PRODUCT SUPPORT BULLETIN BULLETIN NO. 319

MACHINE: Grabber LS

SUBJECT: One-man/two-man Selector Switch Replacement Kit – 98330135

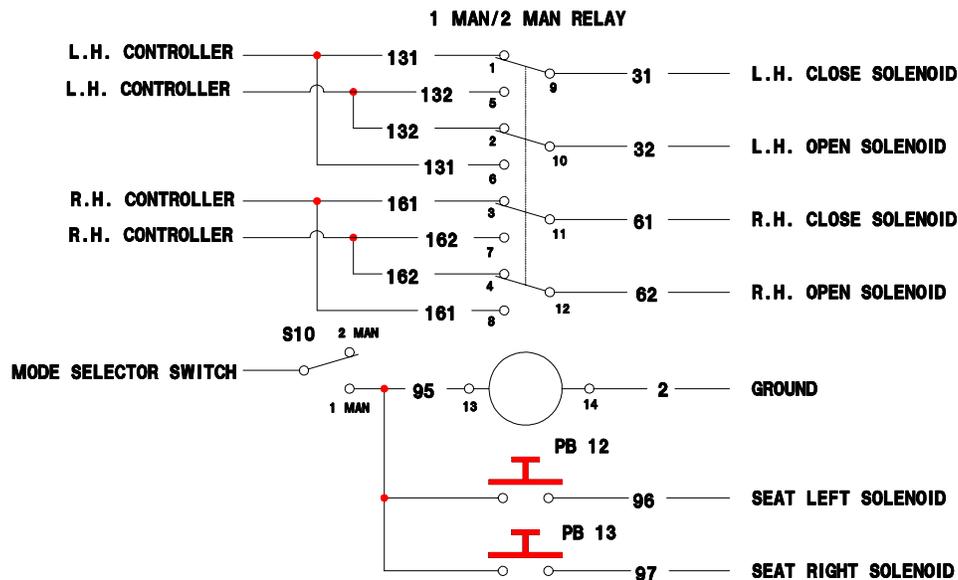
This kit has been developed to replace the One-man/two-man Selector Switch, p/n 78891505. The kit, p/n 98330135 consists of a SPDT toggle switch, p/n 5123593, a relay, p/n 5195882, hardware and installation instructions.

This kit will replace the existing selector switch with a more reliable toggle switch and relay. Installation involves removing the existing switch and mounting and wiring the new switch and relay. Installation should take about 1 hour.

A schematic drawing of the revised wiring is shown below.
